Your Ref
APP/14/00824
Our Ref
PLAN-007263
Date
04/09/2014

Proposal: Erection of a temporary building for storage purposes.

Site: Lewmar Marine Ltd, Southmoor Lane, Havant, PO9 1JJ

APP/14/00824

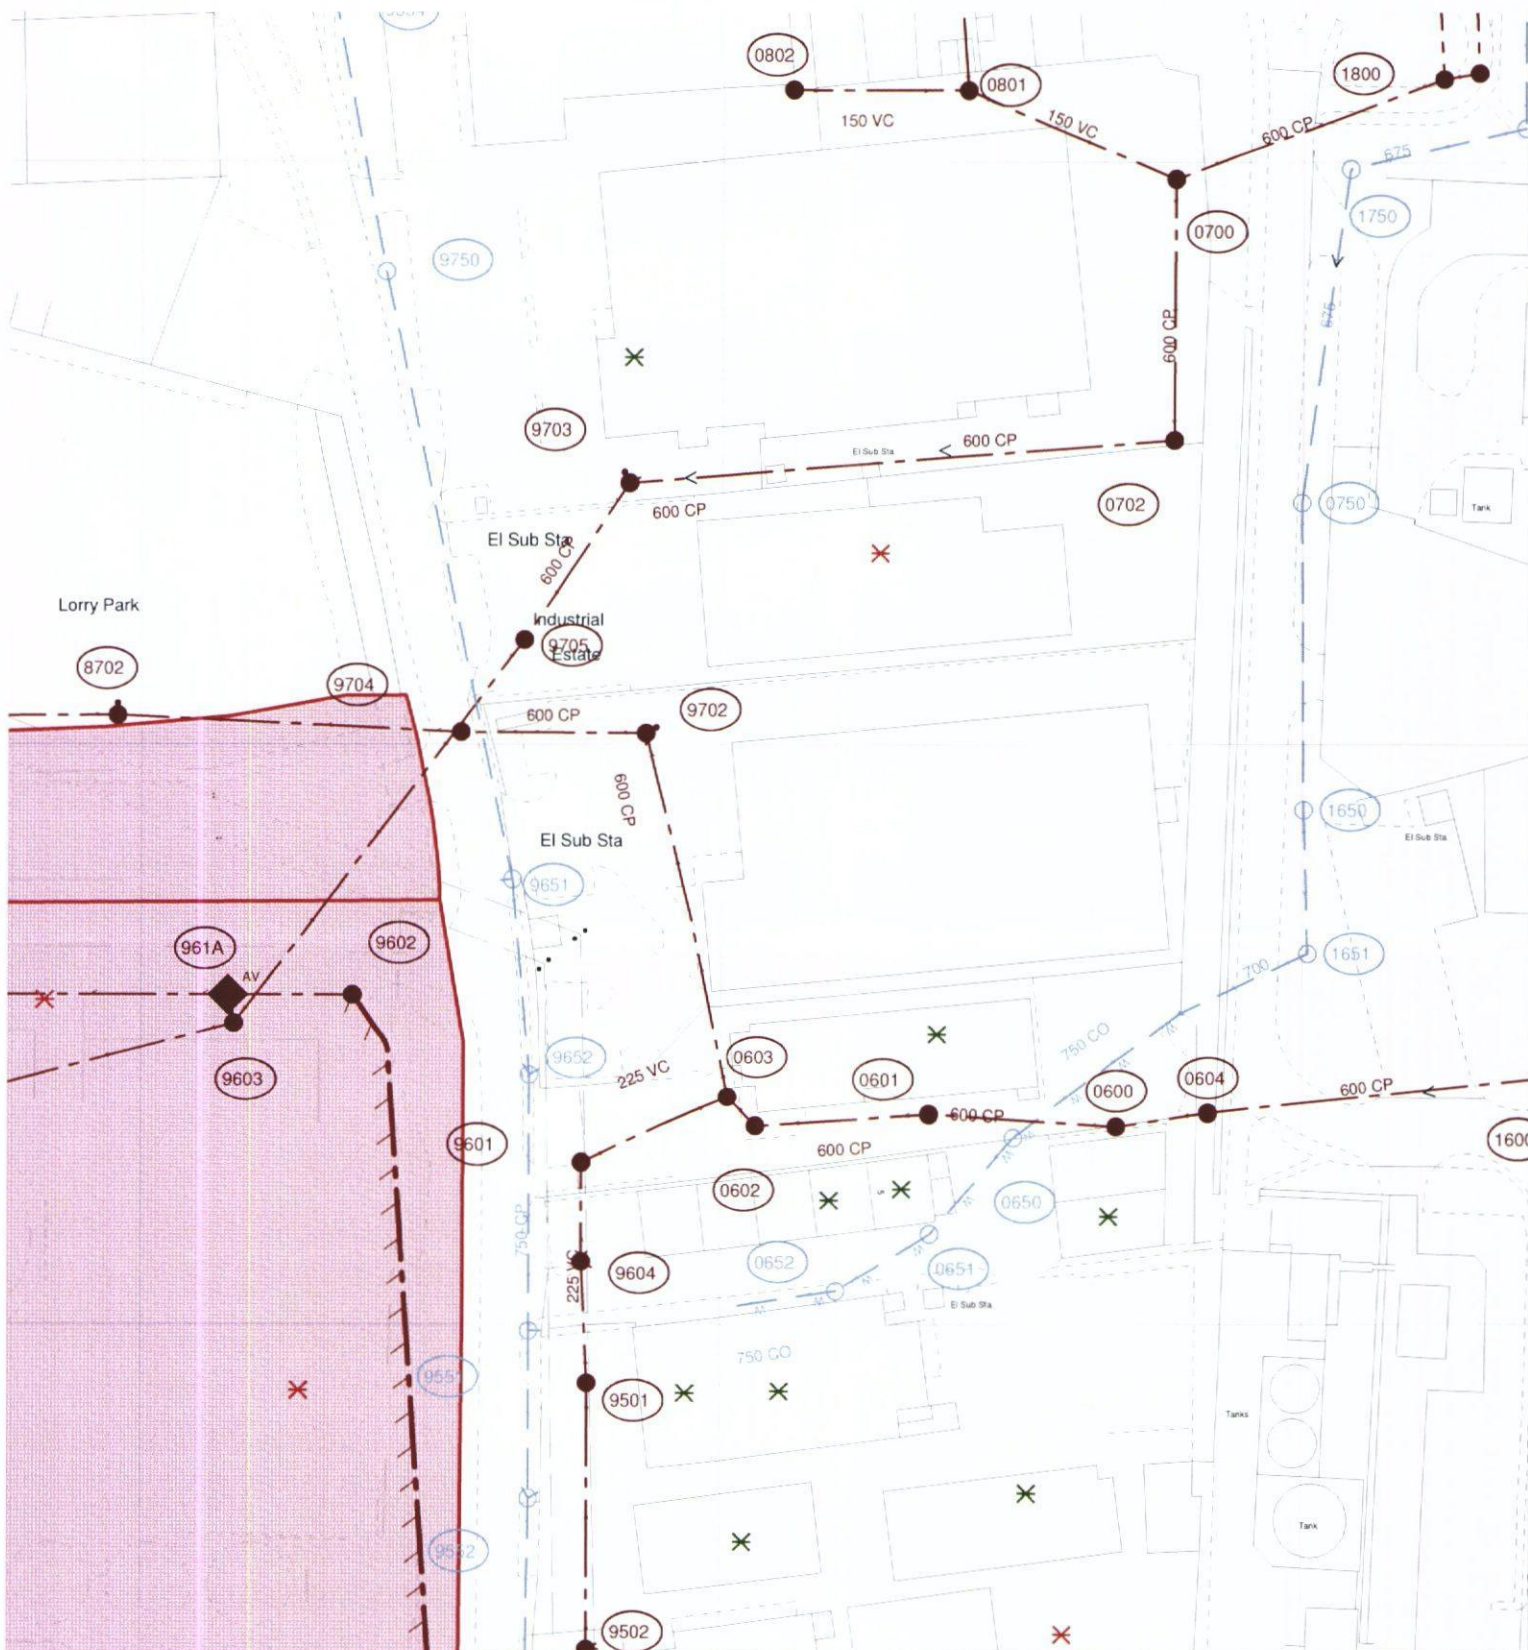
Please find attached a plan of the sewer records showing the approximate position of a public foul sewer and surface water culverted water course within the site. The exact position of the public sewers must be determined on site by the applicant before the layout of the proposed development is finalised.

-No development or new tree planting should be located within 4 metres either side of the centreline of the public sewers and all existing infrastructure should be protected during the course of construction works.

-No new soakaways should be located within 5 metres of a public sewer.
